Access Compliance Report Public Rights-of-Way (Curb Ramps)

Main Street: BOLSA_AVE Cross Street: HUNTER_LN Location: SE

ADA ID: RPRK211005134330 Ramp Type: Type 1 - Perpendicular Diagonal Initial Pass/Fail: Fail Overall Compliance: No Severity Score: 15

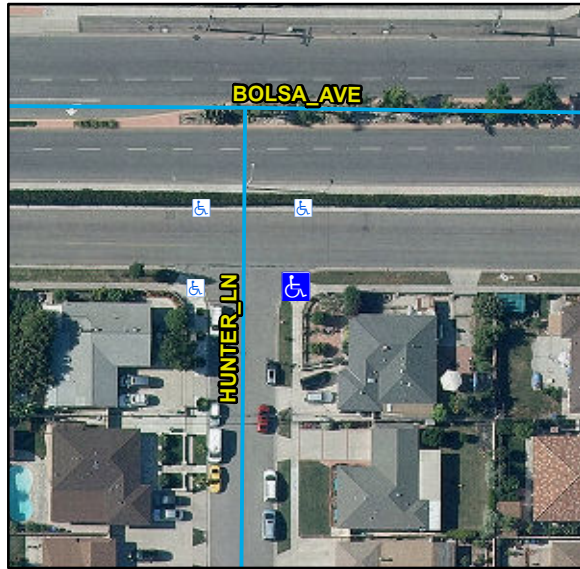
Compliance	Description	Data	Compliance	Description	Data
N/A	Ramp Length (in)	100	N/A	Flare Type LT	
Yes	Ramp Width (in)	48			N/A
No	Ramp Run Slope (%)	10.5	N/A	Flare Slope LT (%)	N/A
Yes	Ramp Cross Slope (%)	1.2	N/A	Flare Traversable LT	N/A
N/A	Landing Present	N/A	N/A	Flare Type RT	
N/A	Landing Length (in)	N/A			N/A
N/A	Landing Width (in)	N/A	N/A	Flare Slope RT (%)	N/A
N/A	Landing Run Slope (%)	N/A	N/A	Flare Traversable RT	N/A
N/A	Landing Cross Slope (%)	N/A	N/A	DWS Provided	N/A
N/A	Landing Movement Obstructed?	N/A	N/A	DWS Contrast	N/A
	Landing Movement Type	N/A	N/A	DWS Length (in)	N/A
N/A	Landing Shared	N/A	N/A	DWS Full Width	N/A
N/A	Clear Space	Yes	N/A	DWS Offset Left (in)	N/A
N/A	Clear Space To Crosswalk (in)	N/A	N/A	DWS Offset Right (in)	N/A
N/A	Marked Crosswalk 1	No	N/A	Marked Crosswalk 2	No
	Crossing 1 Direction	N		Crossing 2 Direction	W
	Marked Crosswalk 1 Width (in)	N/A		Marked Crosswalk 2 Width (in)	N/A

N/A	Ramp Inside Crosswalk 1	N/A	Yes	Ramp Inside Crosswalk 2	N/A
	Crossing 1 Slope (%)	6.5		Crossing 2 Slope (%)	2.6
	Crossing 1 Cross Slope (%)	2		Crossing 2 Cross Slope (%)	2.9
N/A	Gutter Ponding	N/A	No	Curb Slope	14.6
Yes	Gutter Lip Height (in)	0		Road Run Slope (%)	1.7
N/A	Gutter Run Slope (%)	N/A		Road Cross Slope (%)	2.6
N/A	Gutter Cross Slope (%)	N/A			
Yes	Overall Surface Condition: Acceptable		Yes	Perp Joint Present	Yes
	Cross Gutter Present?	No		Spandrel Present?	No
	Replace Cross Gutter?	N/A		Replace Spandrel?	N/A

Remove & Replace Curb Ramp With Two New Directional Ramps or Equivalent.

R304.2.2, STD 1115
